## **Pilot Region-Based Optimization Program for Fund-Lead Sites in EPA Region 3**

### **Site Optimization Tracker: Havertown PCP Site Havertown, Pennsylvania**

EPA 542-R-06-006j  
December 2006  
[www.epa.gov](http://www.epa.gov)

December 30, 2005

**FIGURE 4-1. POTENTIOMETRIC SURFACE FOR SHALLOW GROUNDWATER UNDER PUMPING CONDITIONS (APPROXIMATELY 5 TO 20 FEET BGS).**

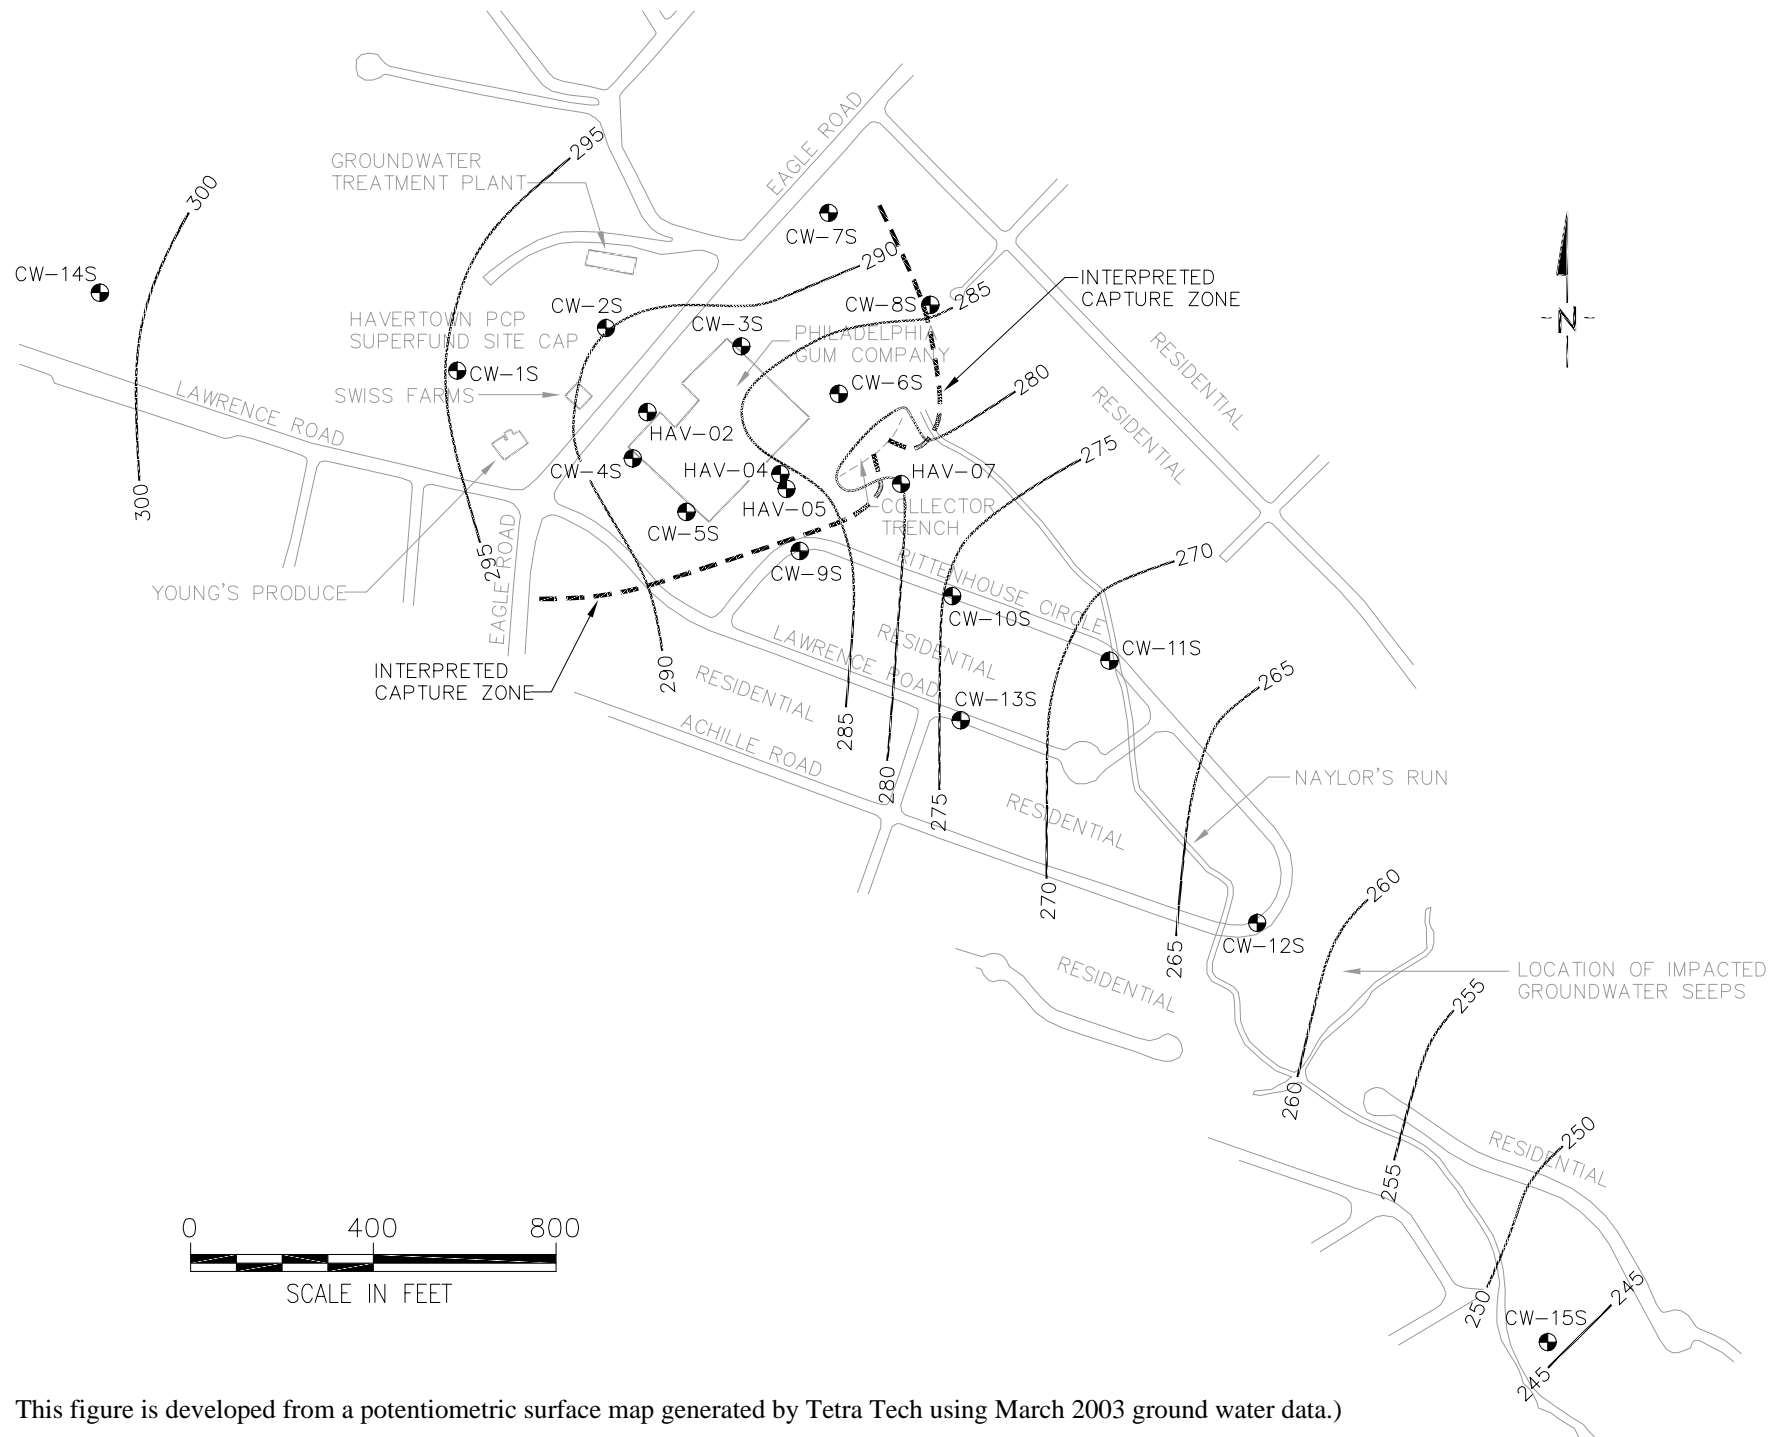
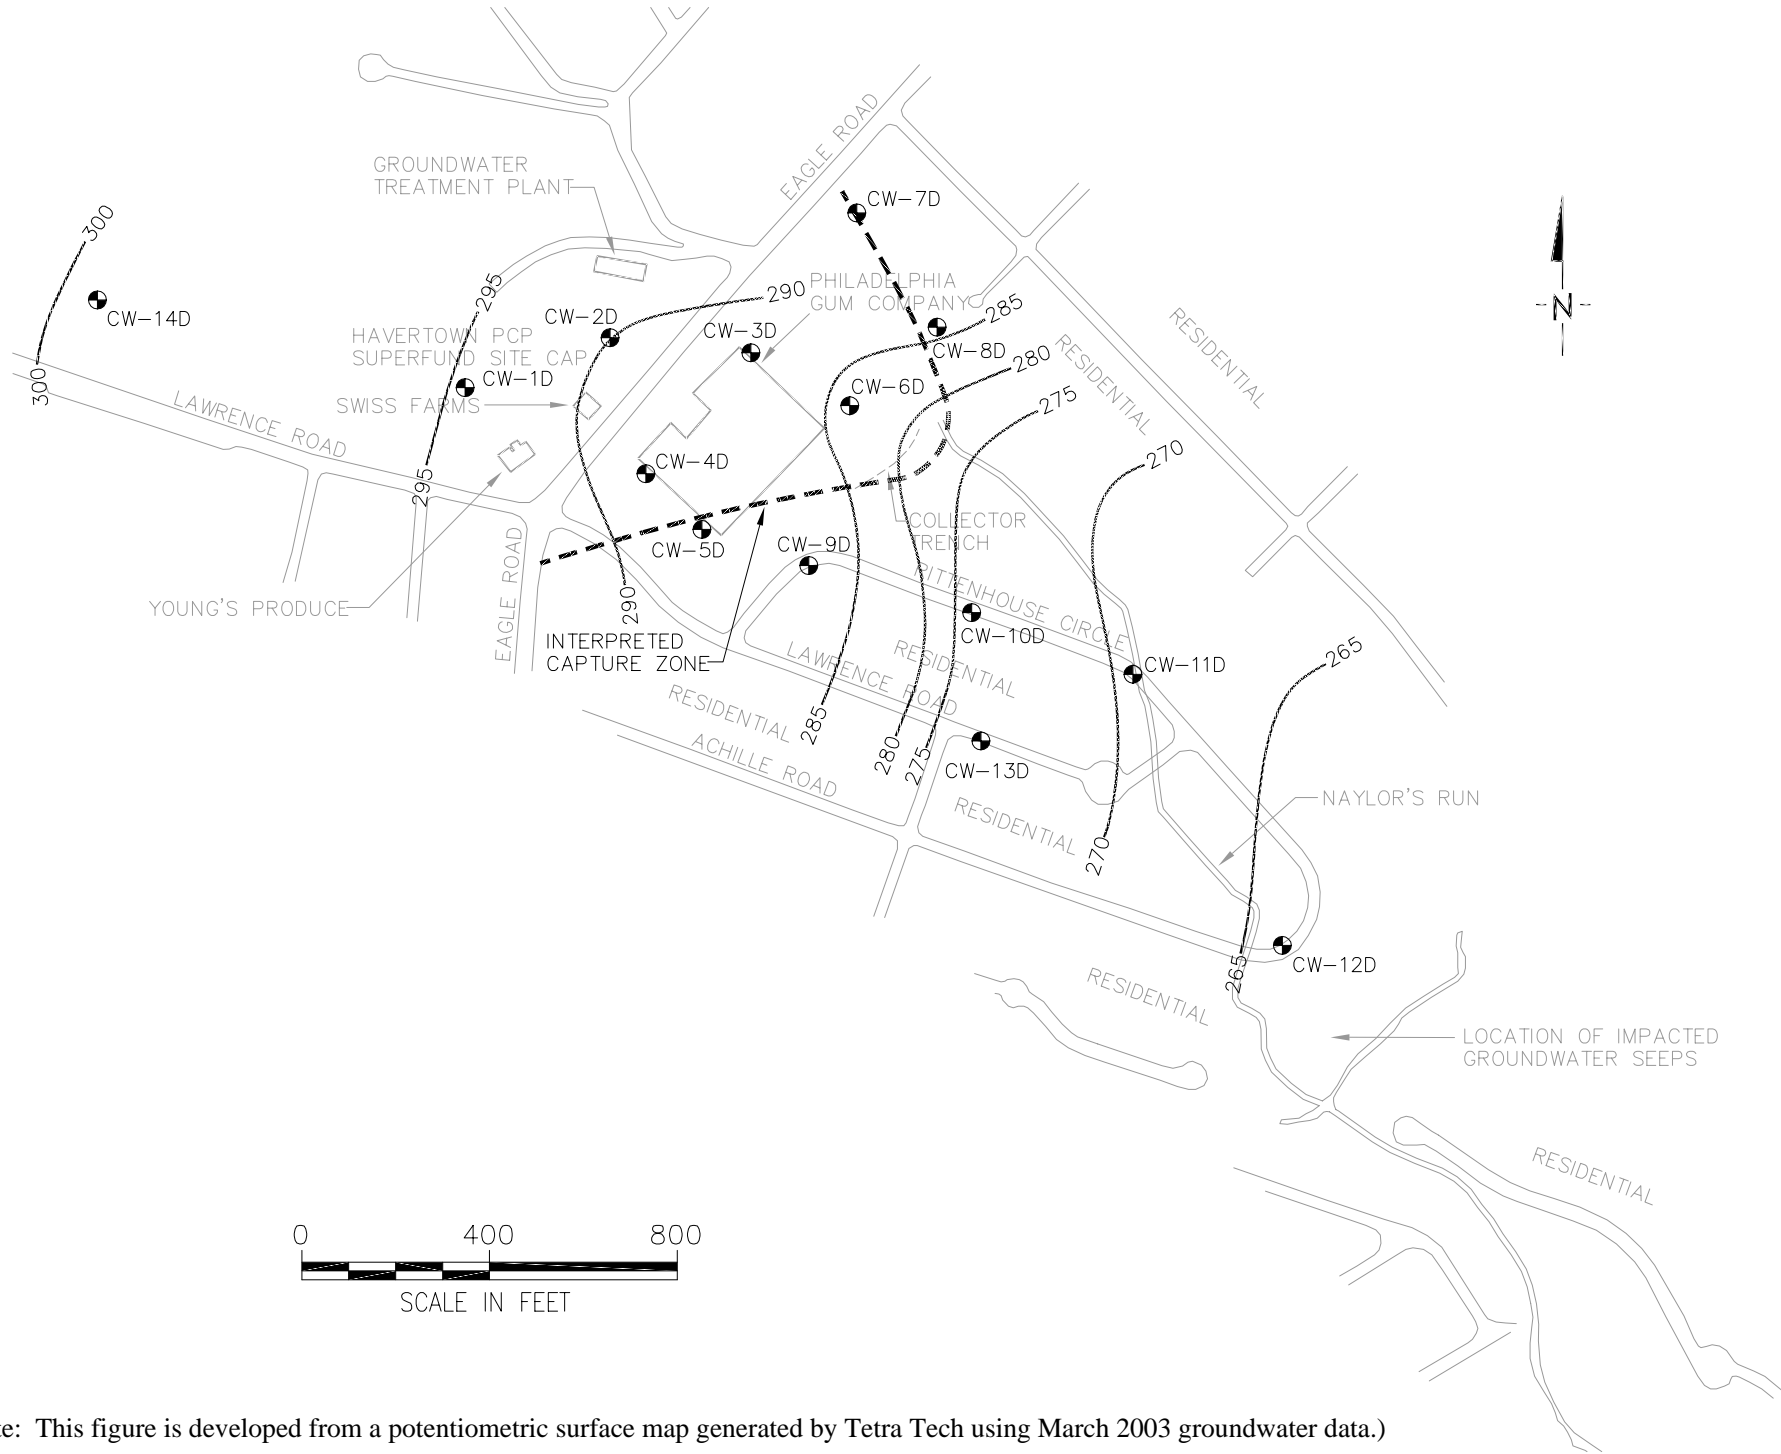
Water levels collected in both the shallow zone (overburden) and deep zone (bedrock) in March 2003 have been used by the site team to generate potentiometric surface maps. These maps are presented in Figures 4-1 and 4-2. Approximately 29 measurement points are used to generate the shallow potentiometric surface map, and approximately 14 measurement points are used to generate the deep potentiometric surface map. Both figures show ground water flow to the southeast, and both figures show the influence of the collector drain. As expected, the influence of the collector drain in the shallow zone is more predominant than the influence in the deeper zone. This is partially due to the use of water level measurement points within the drain when generating the shallow potentiometric surface. Nevertheless, the influence of the drain on the deeper water level measurements suggests that, under pumping conditions, some water in the deeper aquifer is entrained by the drain. These two figures, when compared with each other, can be used to interpret vertical ground water flow, but no easily discernible trend is recognized.

As part of this report, the OSE team has used the March 2003 potentiometric surface maps generated by the site team to interpret the horizontal capture in both the shallow and deep zones. The interpreted areas of capture are depicted in Figures 4-1 and 4-2, with the shallow capture zone more extensive than the deeper capture zone. Therefore, ground water that flows up from within the deeper capture zone should be within the shallower capture zone. These preliminary analyses consider only one round of water levels and do not rigorously consider vertical flow. Because water levels may change seasonally affecting both horizontal and vertical flow, a more thorough capture zone analysis is merited.

south as originally planned due to the residences. Nevertheless, the surface water contamination in Naylor's Run has decreased, and the interpreted shallow capture zone appears to provide capture for the most contaminated portions of the site, including the contamination at CW-4 and CW-5. This contrasts with a more thorough capture zone evaluation conducted by the site team with the water levels collected during December 2002 (not provided in this report). The deeper capture zone interpreted from the March 2003 data is also fairly extensive but does not appear to include the contamination at CW-4 and CW-5.
